Nyberg Custom Homes LLC

As requested by the Builder of the residential property located at 2123 NW Killarney Ln, Lee's Summit, MO 64081, I have viewed a photo of the installed double 2x10 header above an exterior door. I have calculated the load of the header and determined that a double 2x10 header is adequate as installed.

PLAN 4365 HEADER OVER SLIDER

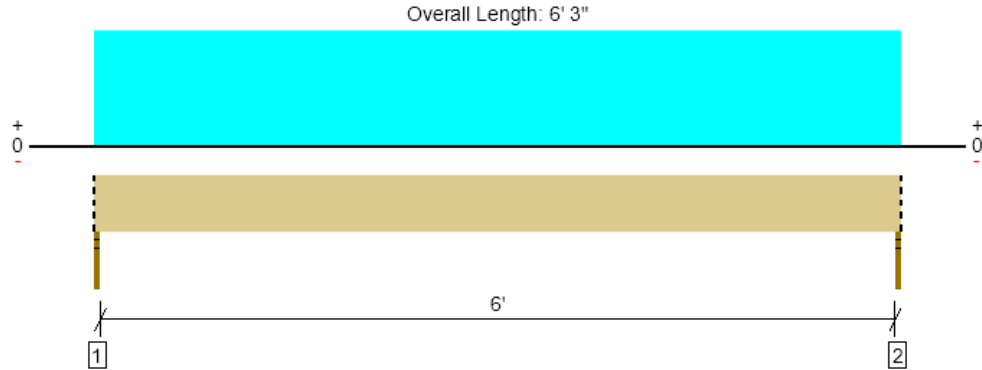
A photo of the header is included below for reference, and the calculations for the header's adequacy included. The original design was to install a double 2x12 header, but the double 2x10 header was used due to space restrictions.
